**Re: Jackson Hydroelectric Project, FERC No. P-2157
Side Channel Enhancements – Ramping Rate Evaluation Plan
License Article 405**

Side Channel Enhancements Ramping Rate Evaluation Plan

License Article 405

Figure 1. Side Channel Enhancements in Lower Sultan River.....	3
--	---

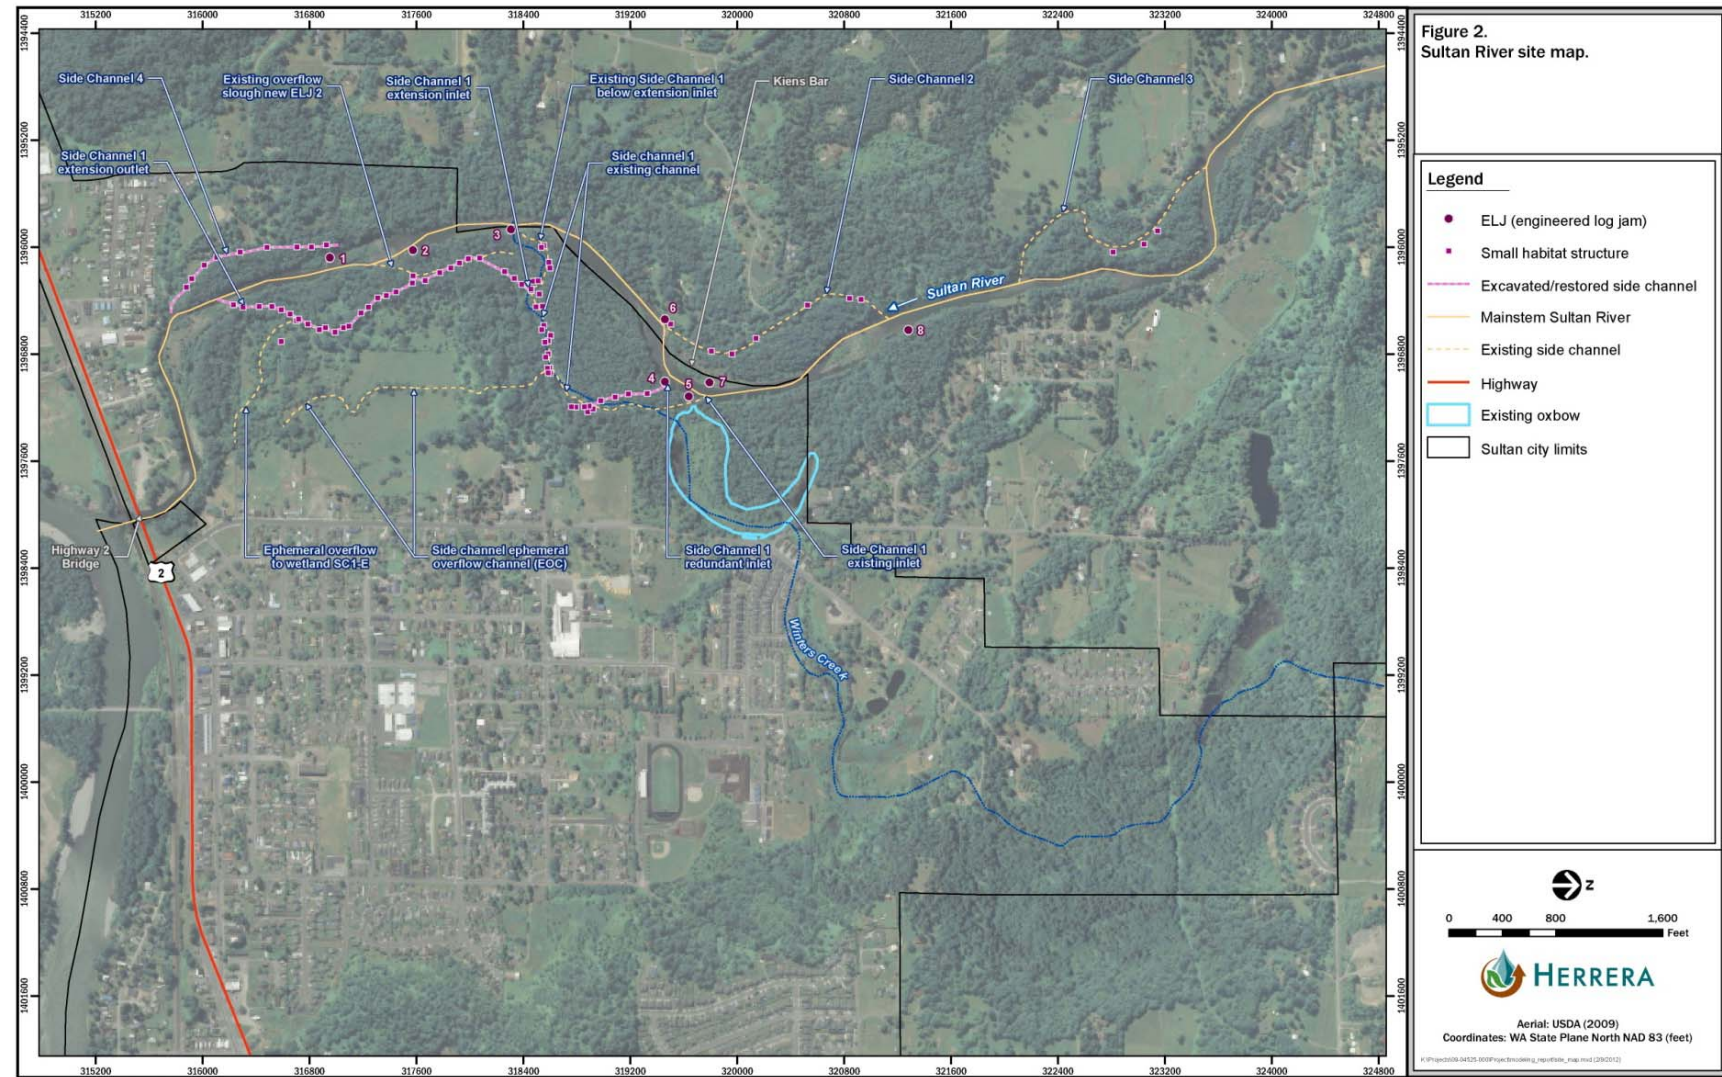
Comment [AS1]: Although the minimum flow is estimated to be 300 cfs, we don't know what happens in the side channels in case flows go below 300. I would like to know what happens in the side channels when the minimum instream flows are lower, when Spada Lake is below 1420.

Comment [AS2]: We need to know the water levels throughout the side channels, to understand if there are areas where fish can get trapped within the sidechannels. Connectivity at the upstream and downstream end is important, however if fish are trapped in the sidechannel and can't leave, we should know where those areas are.

Number	ARC Comment	District Response
1	<p>Tulalip Tribes, Email dated 12/20/2012 Section 2 Methods and Schedule:</p> <p>Although the minimum flow is estimated to be 300 cfs, we don't know what happens in the side channels in case flows go below 300. I would like to know what happens in the side channels when the minimum flows are lower, when Spada Lake is below 1420.</p>	<p>The District discussed these comments with the ARC on 1/16/2013. Discussion points included:</p> <p>In the event of a declared drought warranting reductions in minimum flows below 300 cfs, the District will adopt a conservative ramping rate as it makes this transition. The District will also conduct focused qualitative surveys during this flow reduction.</p> <p>The Tulalip Tribes indicated agreement with this approach at the 1/16/2013 ARC meeting.</p>
2	<p>Tulalip Tribes, Email dated 12/20/2012 Section 2 Methods and Schedule:</p> <p>We need to know the water levels throughout the side channels, to understand if there are areas where fish can get trapped within the sidechannels. Connectivity at the upstream and downstream end is important, however if fish are trapped in the sidechannel and can't leave, we should know where those areas are.</p>	<p>The District discussed these comments with the ARC on 1/16/2013. Discussion points included:</p> <p>The connectivity information collected under this plan will supplement the qualitative surveys of functionality and physical habitat measurements described in the SCE Plan. This combined information will describe the potential for stranding in side channel habitats.</p> <p>The Tulalip Tribes indicated agreement with this approach at the 1/16/2013 ARC meeting.</p>
